PRODUCT CHANGE NOTICE

PCN22-041

CBP12-1090BE+
CBP12-1030BE+
CBP-1090BE-1+
CBP-1030BE-1+

Photo Comparison

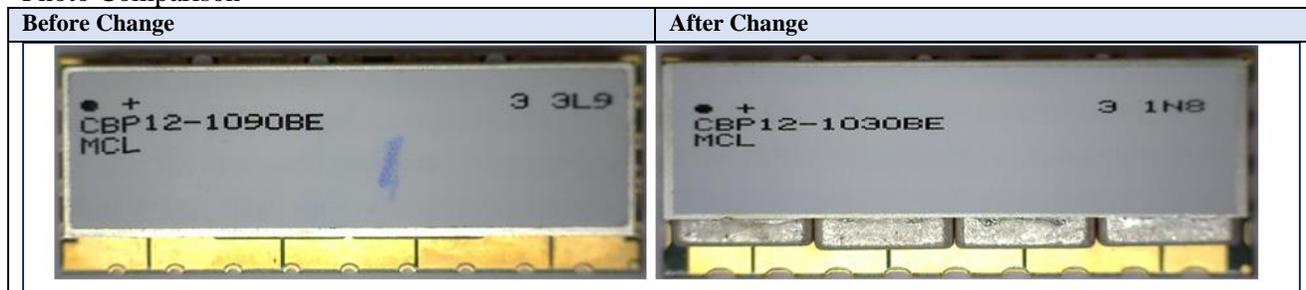
Top cover re-design with change in dimensions.
PCB edge plating added to avoid copper smear in assembly process

- No change to **FIT** (Dimension) or **FUNCTION** (Performance)
- Change to **FORM** (Appearance)
